Product Change Notification / SYST-04BZVW306

ERRATA - dsPIC33CH512MP508 Family Silicon Errata and Data Sheet Clarification

dsPIC33CH512MP508 Family Silicon Errata and Data Sheet Clarification

FIGURE 1-1: I/O RAMP

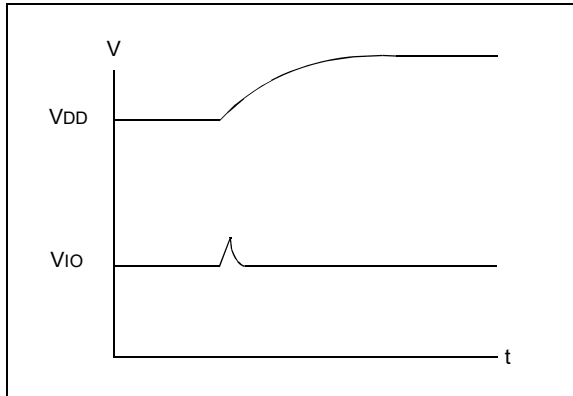
During a fast device power-up, when the VDD ramp is less than 4 mS, the I/O pins may drive up to 100 μ A current for a duration of up to 10 μ S (Figure 1-1).

1. Slow down the VDD ramp time (greater than 4 mS for VDD to ramp 0V to 3.3V).
2. Ensure the circuitry that is connected to the pins can endure this pulse.

Example applications affected may include complementary power switches, where a transient current shoot-through might occur. High-voltage applications with complementary switches should power the high-voltage 200 μ Sec later than powering the dsPIC[®] device to avoid the current shoot-through. This behavior is specific to each device and not affected by aging.

FIGURE 2-2: SUGGESTED PLACEMENT OF THE OSCILLATOR CIRCUIT

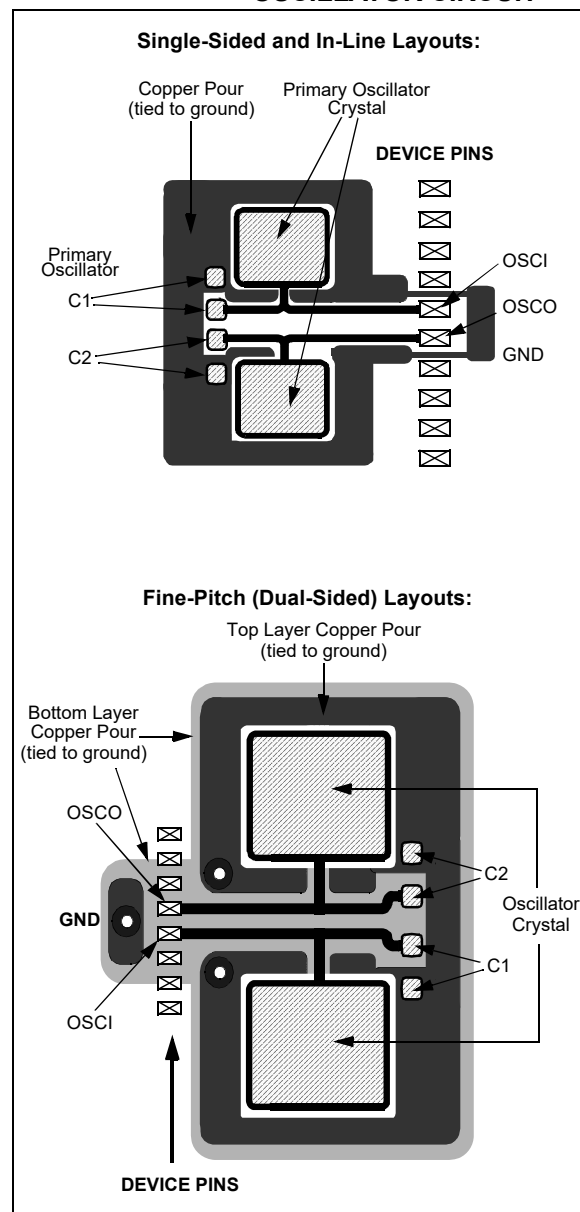
Additional information is added to [Section 2.5 “External Oscillator Pins”](#) and [Section 2.6 “External Oscillator Layout Guidance”](#) is added.

2.6 External Oscillator Layout Guidance

Use best practices during PCB layout to ensure robust start-up and operation. The oscillator circuit should be placed on the same side of the board as the device. Also, place the oscillator circuit close to the respective oscillator pins, not exceeding one-half inch (12 mm) distance between them. The load capacitors should be placed next to the oscillator itself, on the same side of the board. Use a grounded copper pour around the oscillator circuit to isolate it from surrounding circuits. The grounded copper pour should be routed directly to the MCU ground. Do not run any signal traces or power traces inside the ground pour. If using a two-sided board, avoid any traces on the other side of the board where the crystal is placed. Suggested layouts are shown in [Figure 2-2](#). With fine-pitch packages, it is not always possible to completely surround the pins and components. A suit-

FIGURE: ADC ANALOG INPUT MODEL

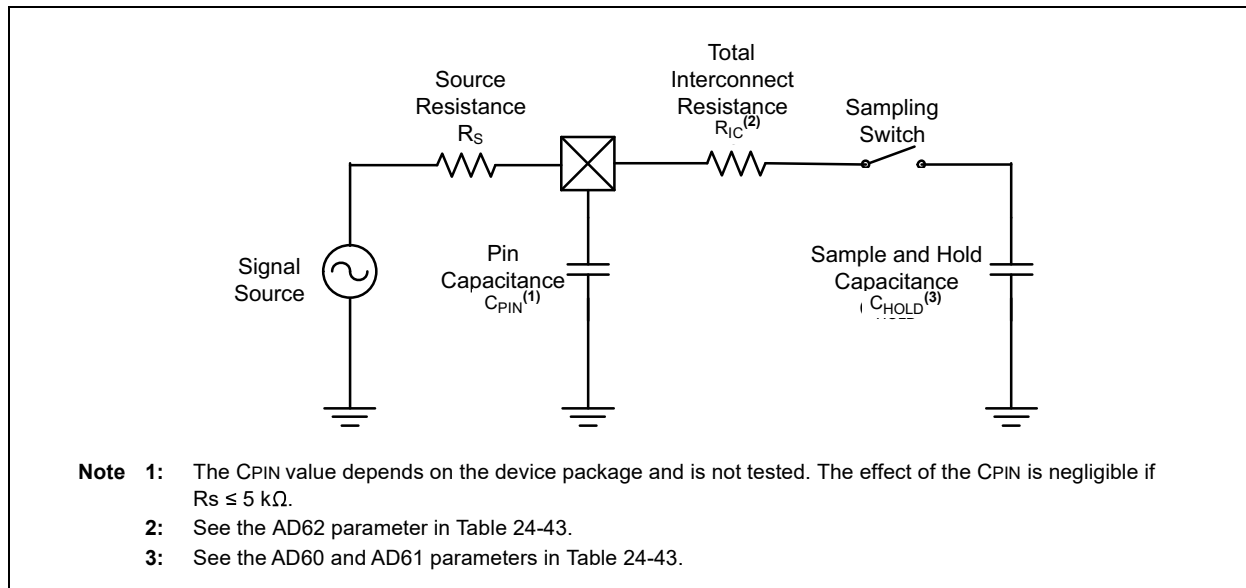
The following [Sampling Time Requirements](#) section has been added to both [Section 3.16 “High-Speed, 12-Bit Analog-to-Digital Converter \(Main Core ADC\)”](#) and [Section 4.7 “High-Speed, 12-Bit Analog-to-Digital Converter \(Secondary Core ADC\)”](#).

The analog input model of the ADC is shown in the figure below.

The total acquisition time for the Analog-to-Digital conversion is a function of the Holding Capacitor (C_{HOLD}) charge time. For the ADC module to meet its specified accuracy, the Holding Capacitor (C_{HOLD}) must be allowed to fully charge to the voltage level on the analog input pin. The Signal Source Impedance (R_S) and the Interconnect Impedance (R_{IC}) combine to affect the time required to charge the C_{HOLD} . The total resistance ($R_S + R_{IC}$) must therefore, be small enough to fully charge the Holding Capacitor within the selected sample time.

FIGURE 21-4: FLASH SECURITY SEGMENTS (SINGLE PARTITION MODE)

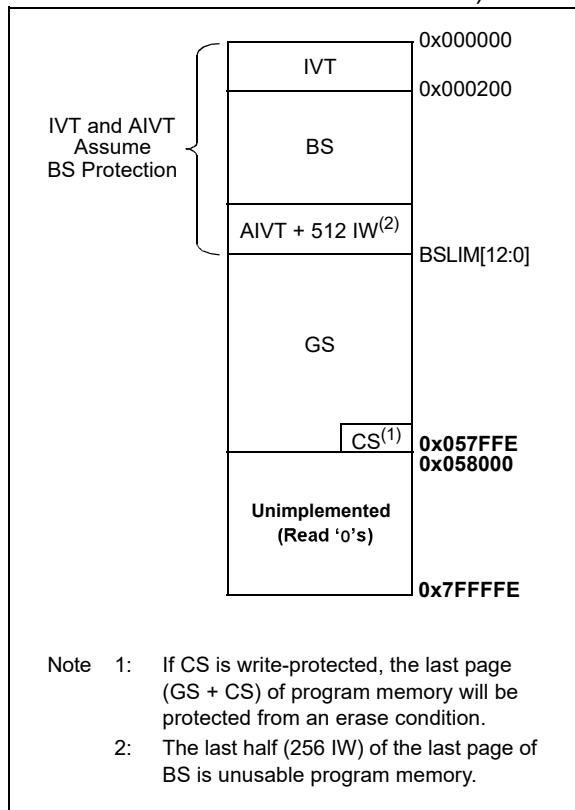
Figure 21-4 has been updated as shown in bold below.

FIGURE 21-5: FLASH SECURITY SEGMENTS (DUAL PARTITION MODE)

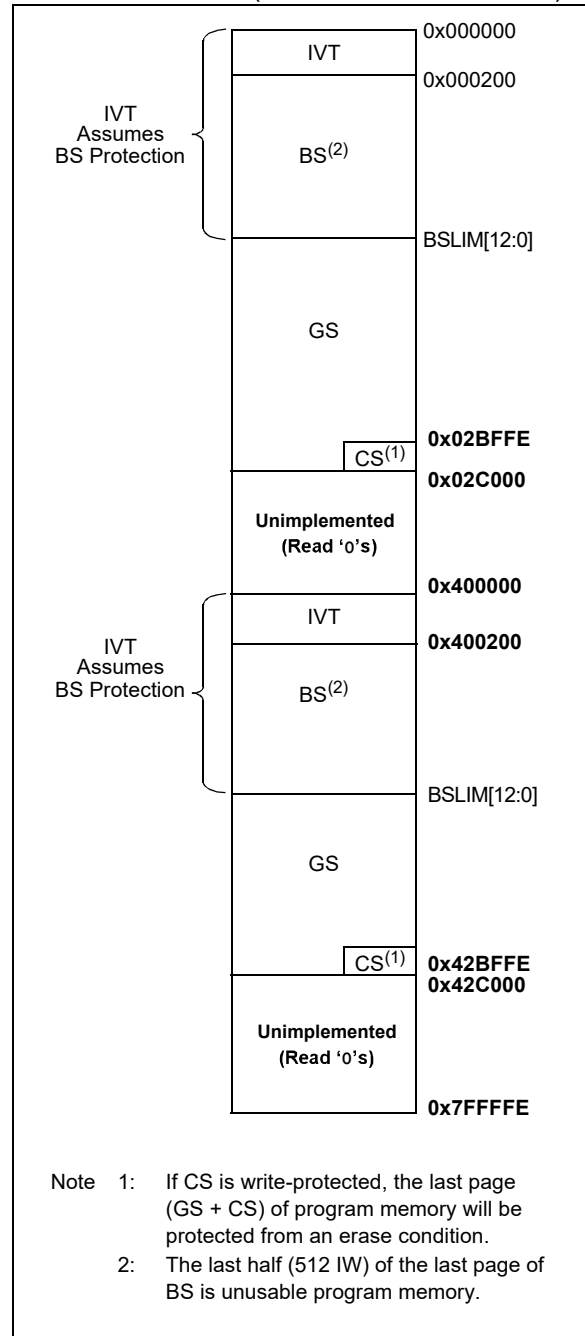
Figure 21-5 has been updated as shown in bold below.

FIGURE 4-3: PRAM (PROGRAM MEMORY) FOR SECONDARY CORE dsPIC33CH512MP508S1 DEVICES

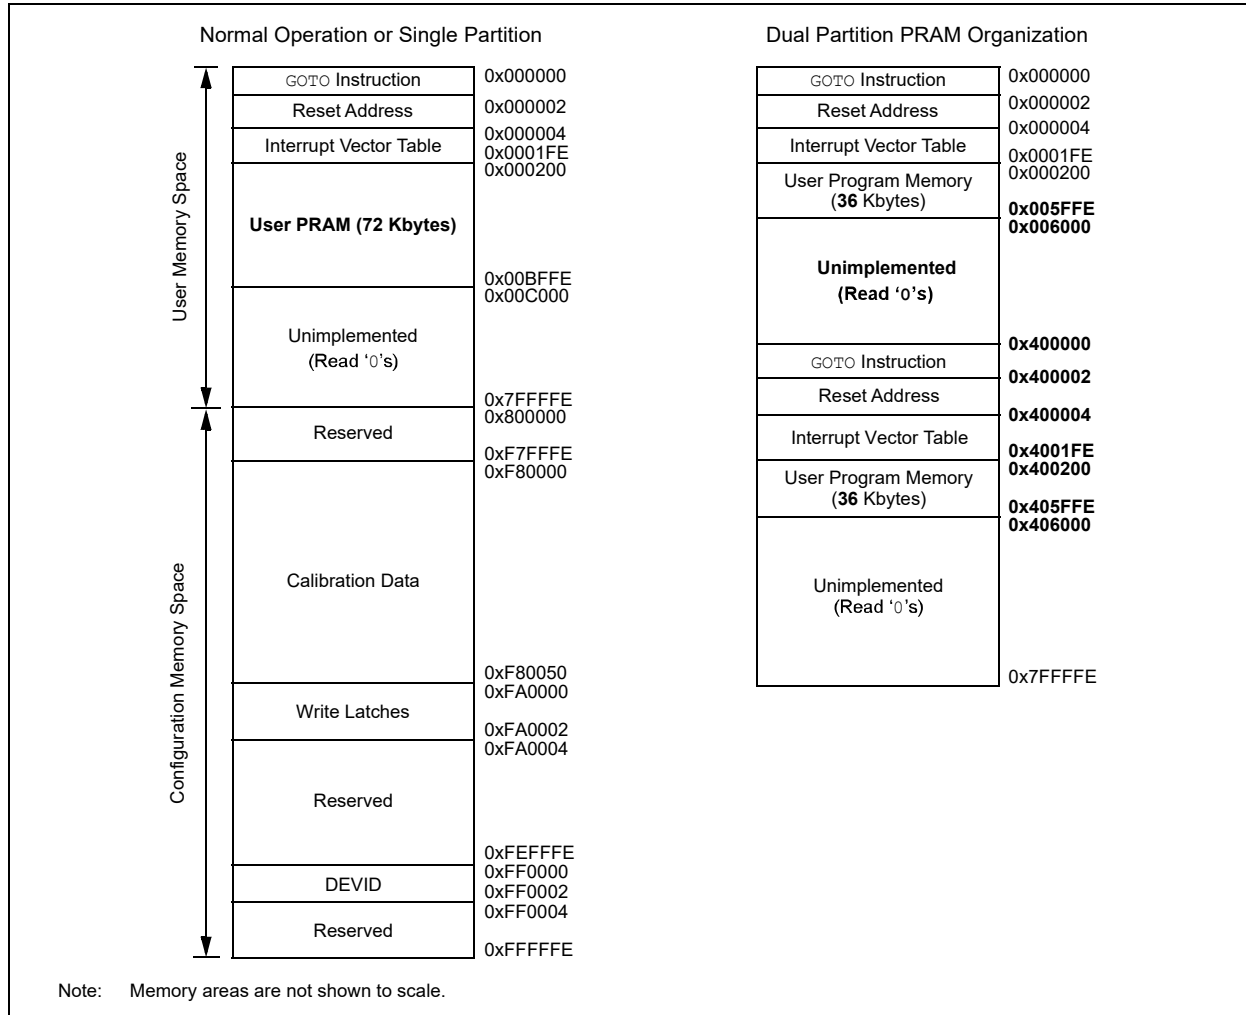
Figure 4-3 has been updated as shown in **bold** below.
